**CHANCE**  
MANUFACTURING CO., INC.

# Service Information

Ride: ZIPPER

Subject: SEAT SAFETY LUG BOLT CHECK

ILLUSTRATION C

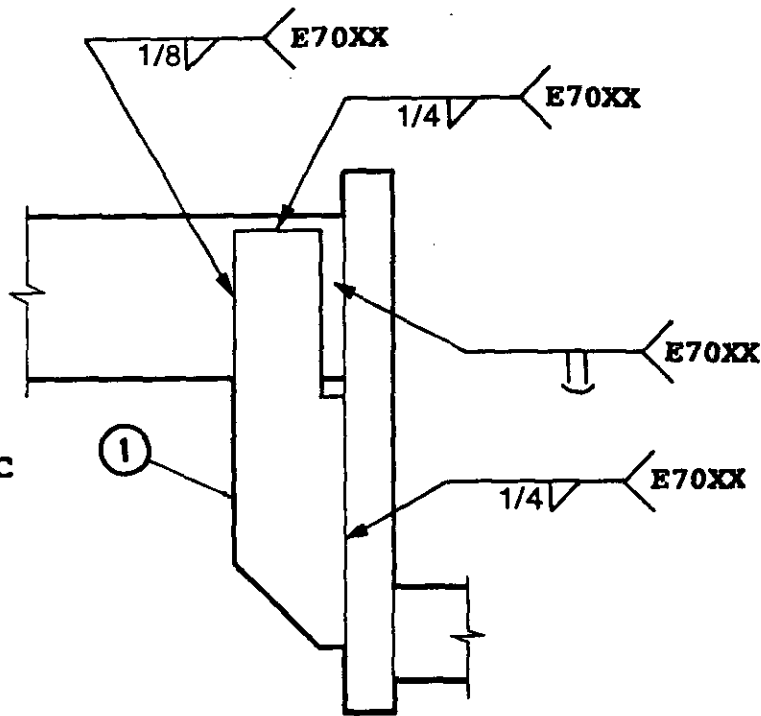
Install kit no. K05-0350-00 as shown in Illustrations B and C. Two plates must be added to each end of every axle frame.

ILLUSTRATION B

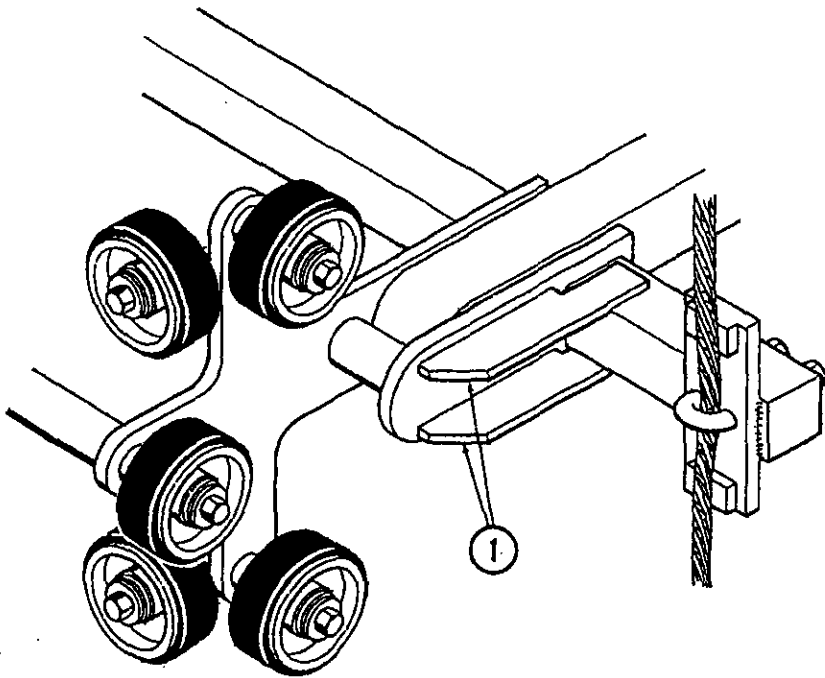
If cracks are found, replace the axle frame with a new part. Do not attempt to weld or otherwise repair a cracked axle frame. Order part number 305-03240 for a new axle frame weldment (does not include wheels).

Install kit no. K05-0350-00 as shown in Illustrations B and C. Two plates must be added to each end of every axle frame.

TROLLEY AXLES  
MUST BE  
PERPENDICULAR(90°)  
TO TRACK

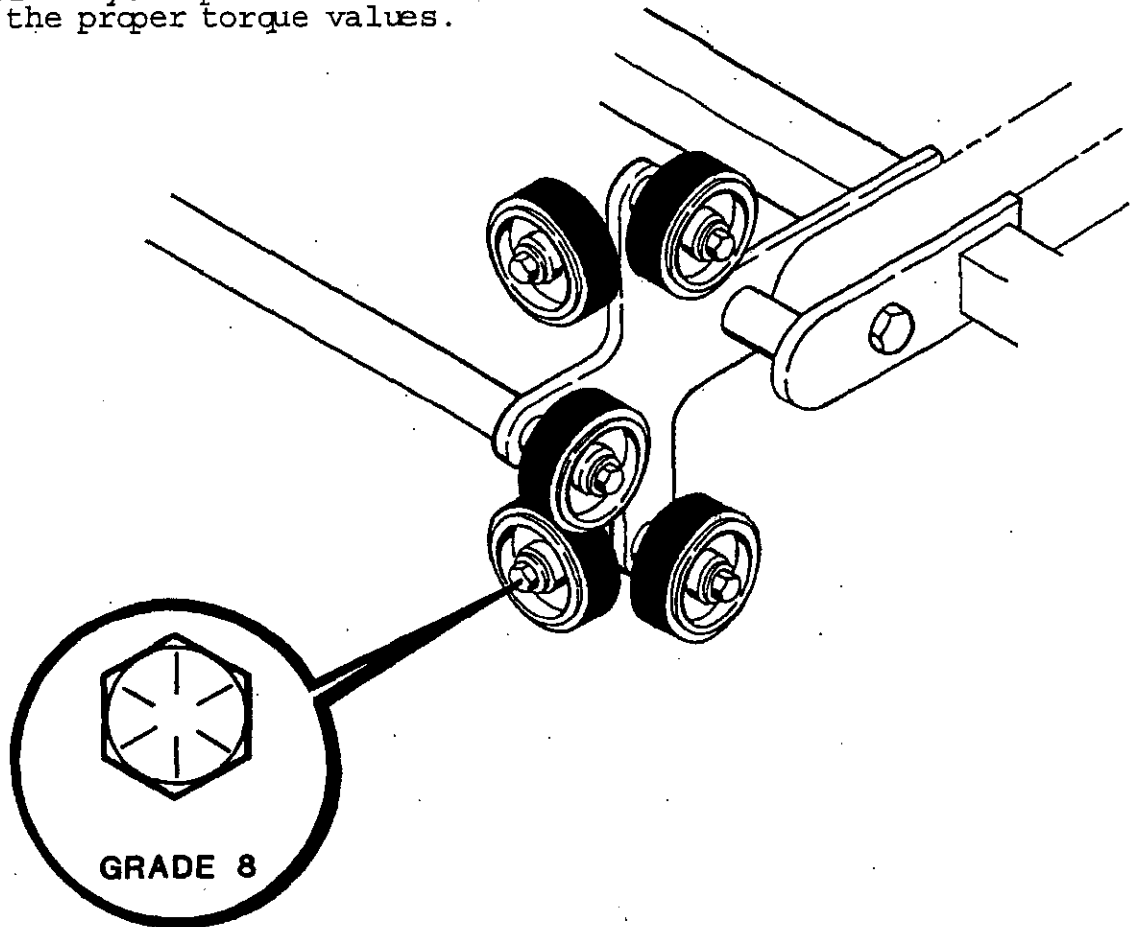
4. All trolley wheels must be secured with grade 8 bolts. Refer to the operation/maintenance manual for the correct length bolt for each wheel on your particular ride and for the proper torque values.

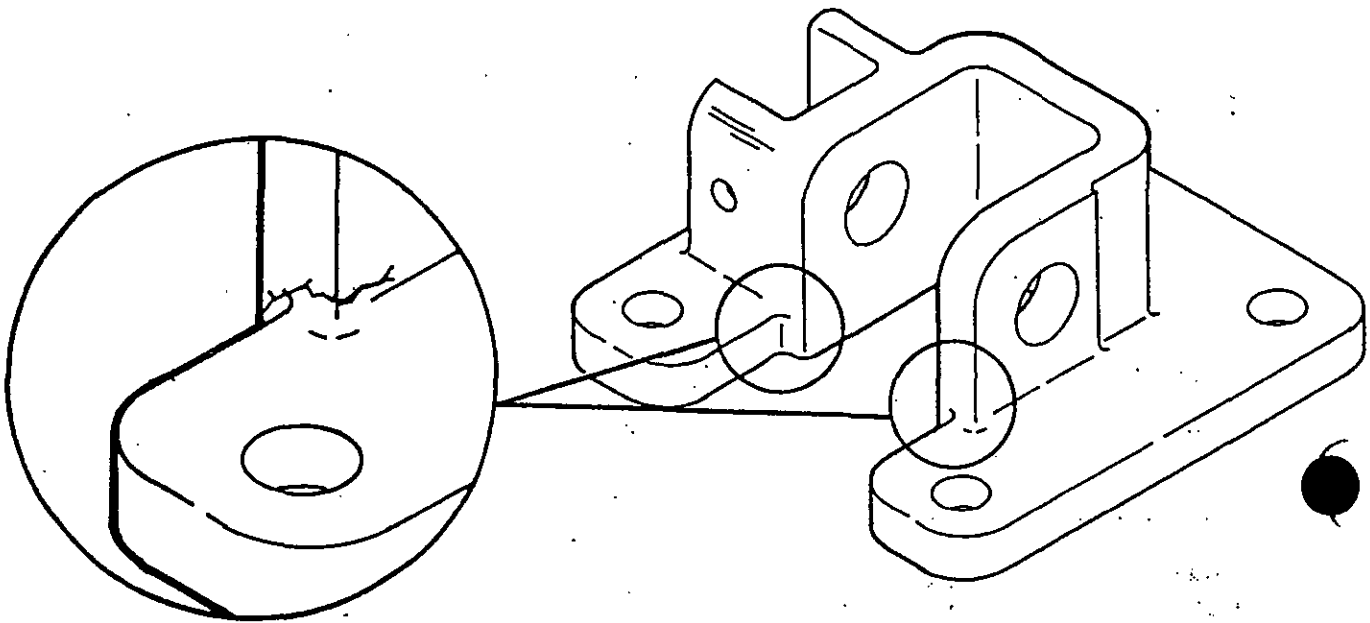
1. Visually inspect seat hanger for cracks in the areas shown on illustration below.
2. If cracks are found, do not operate the ride, call the Chance Customer Service Department at 1-800-CHANCE1.
3. Visual inspection must be done daily, prior to operation of the ride.

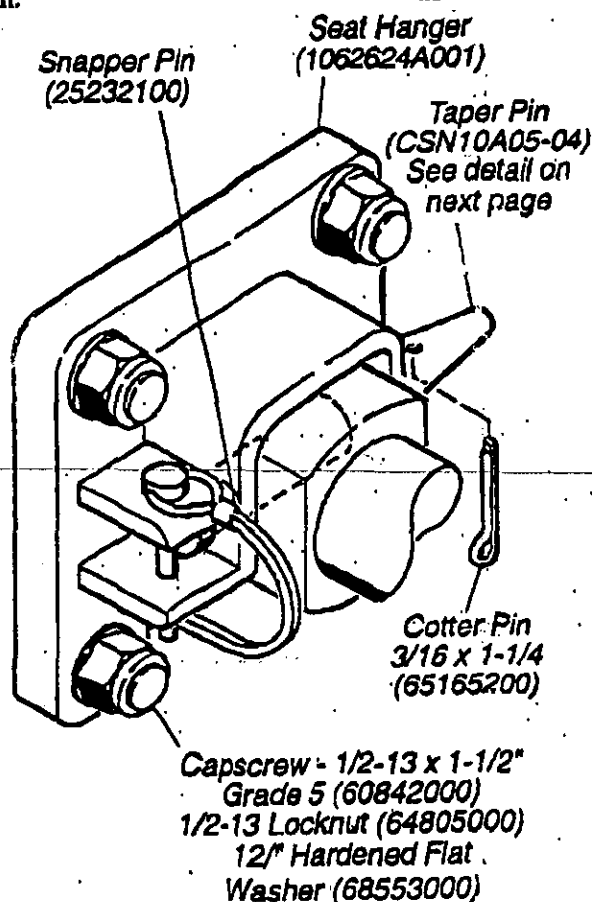
Regardless of which style seat hanger is used, the mounting fasteners must be those specified in the following illustrations. All parts must be installed exactly as shown.

On seats which rack in place on the boom  
A Grade 8 capcrew must be installed through the seat hanger, behind the head of the taper pin. The nut must be tightened until snug. **DO NOT OVER-TIGHTEN.** A cotter pin must be installed in the other end of the taper pin.
